**FINAL**  
**Environmental Impact Report**  
for

**IP Athos LLC's**  
**Athos Renewable Energy Project**

**(SCH No. 2018051021)**

**May 2019**

Figure 1: AASHTO H-20 Loading

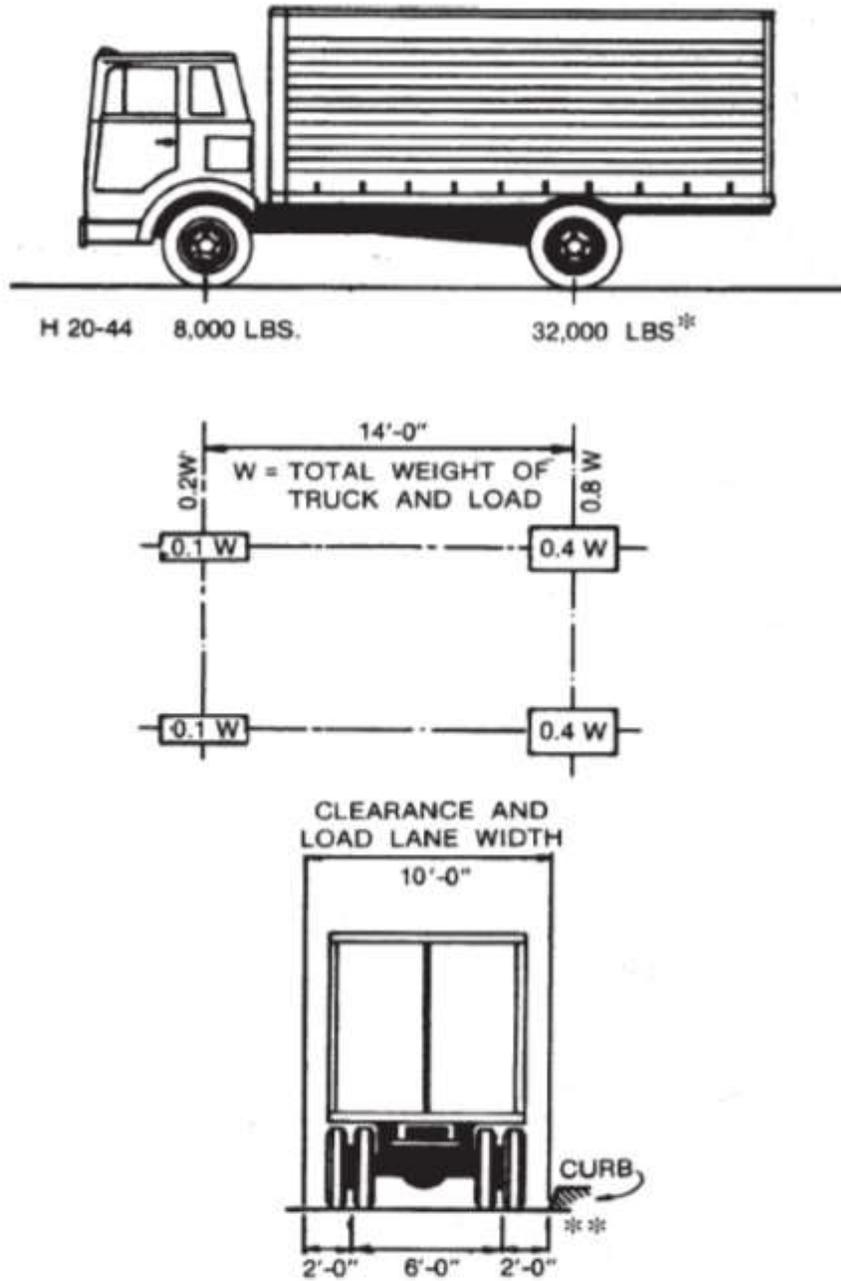
Comment Set A2 – Metropolitan Water District of Southern California (cont.)

A2-5  
cont.

# EXHIBIT A

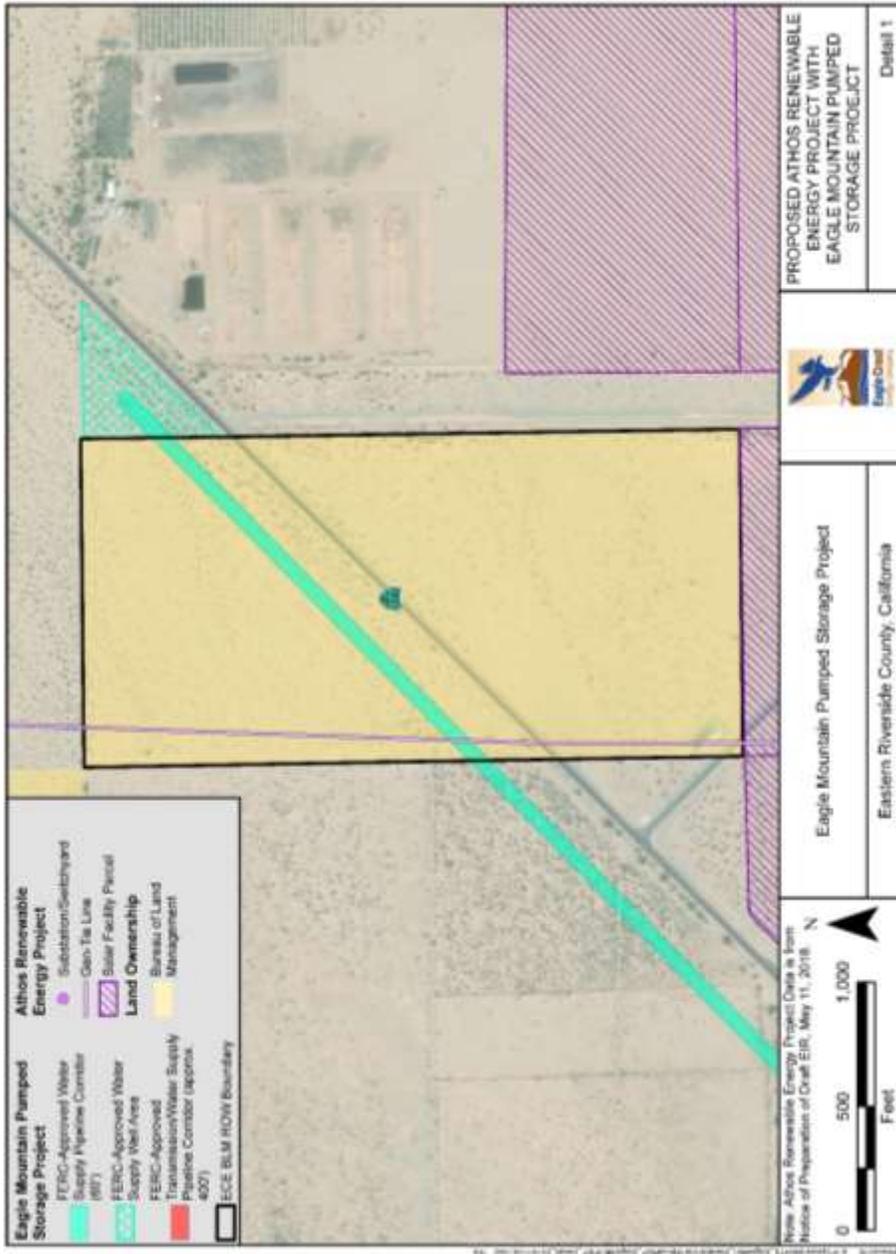
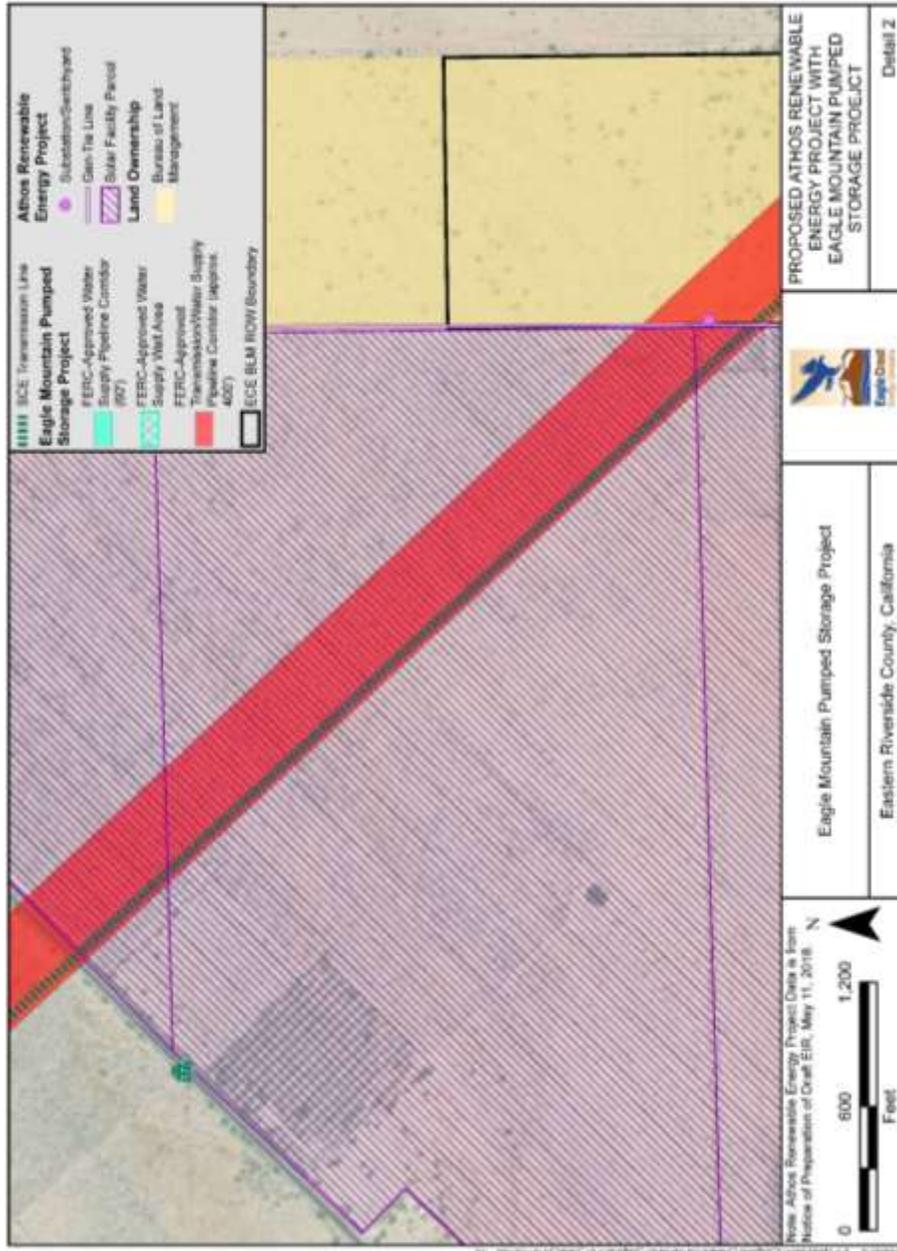
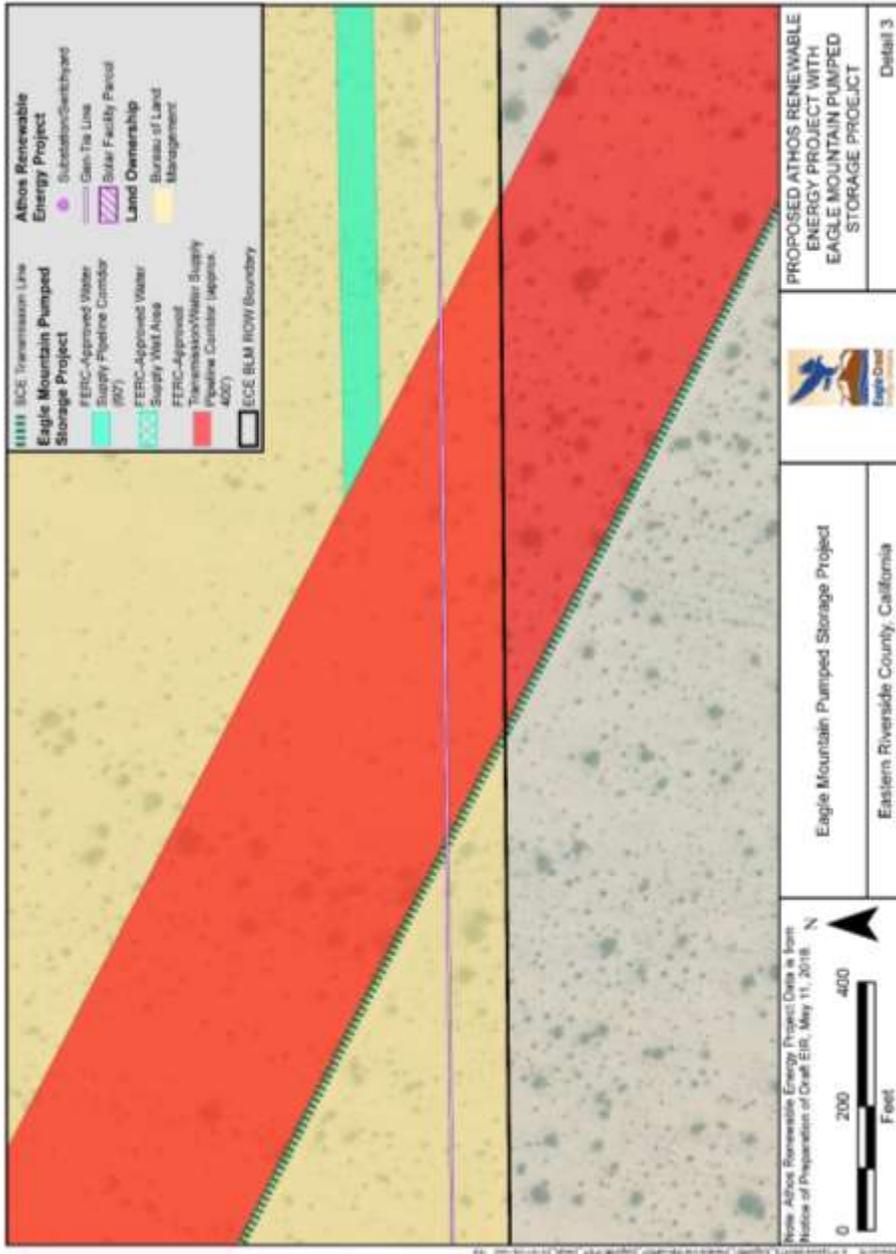
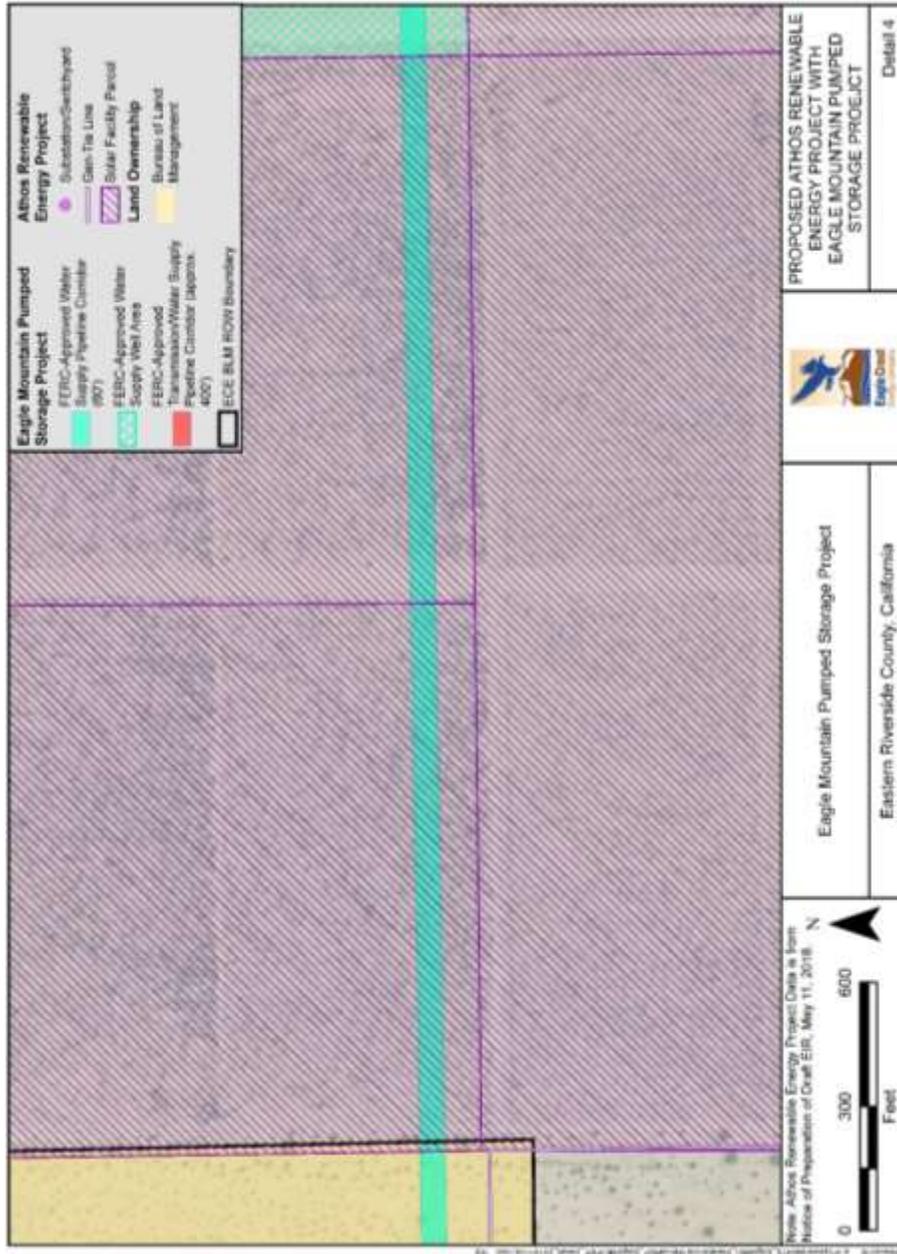
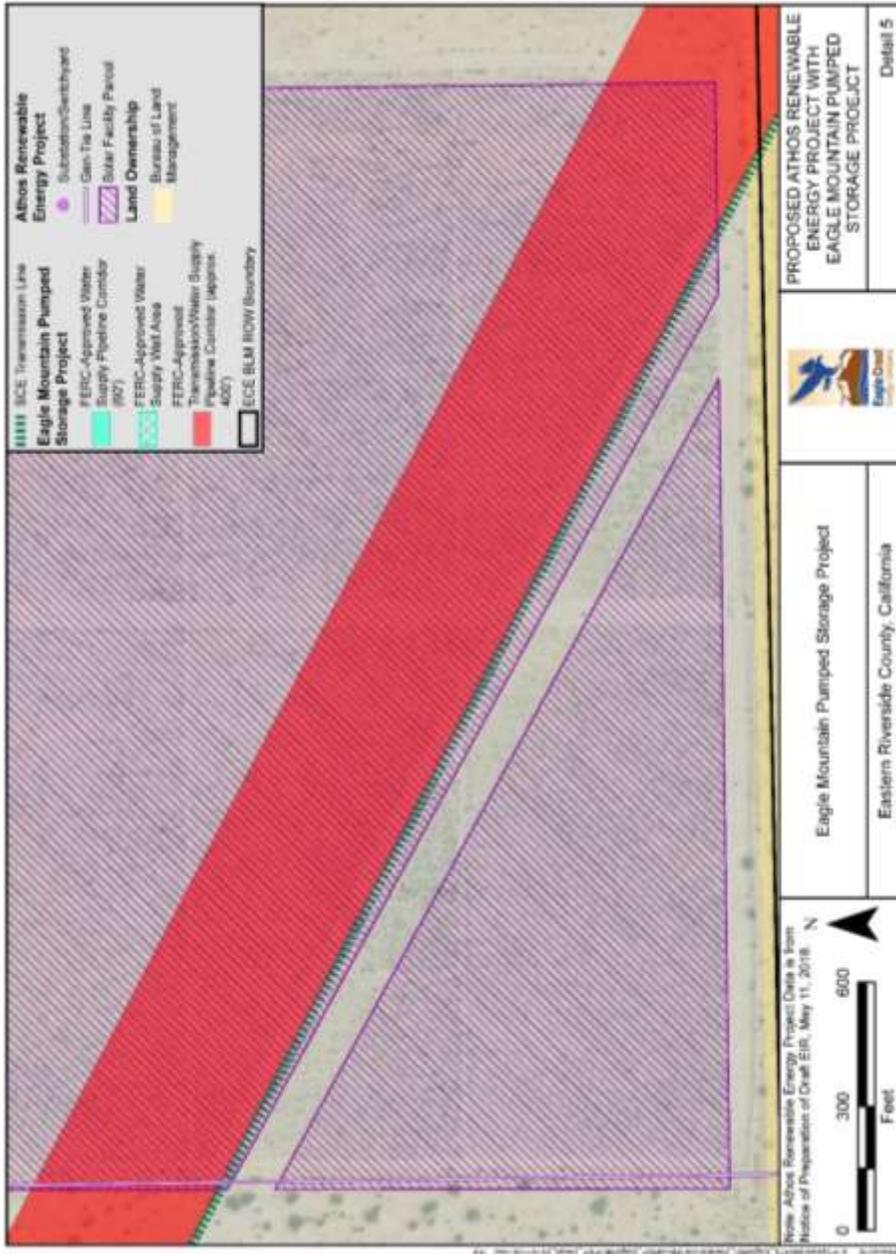
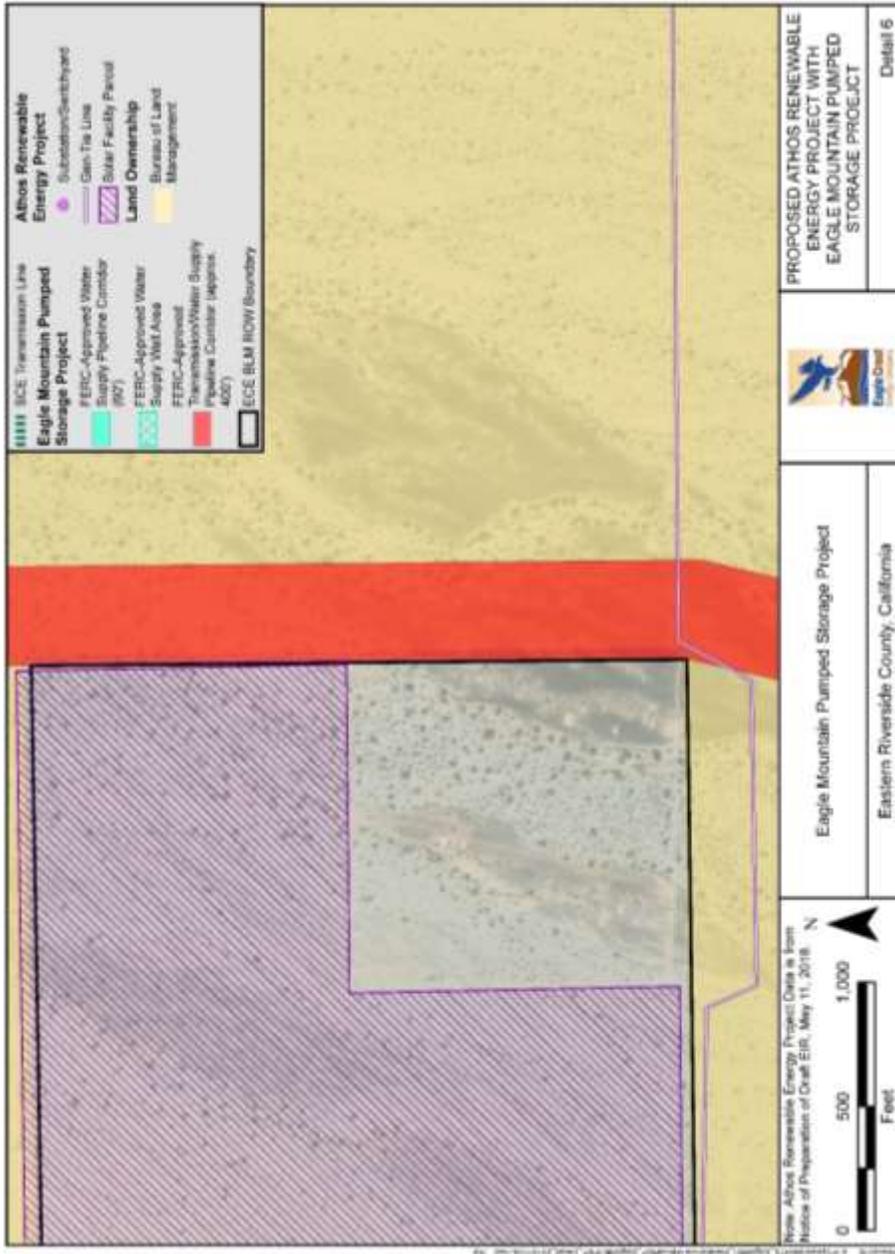
B2-7 cont.

B2-7 cont.

B2-7 cont.

B2-7 cont.

B2-7 cont.

B2-7 cont.
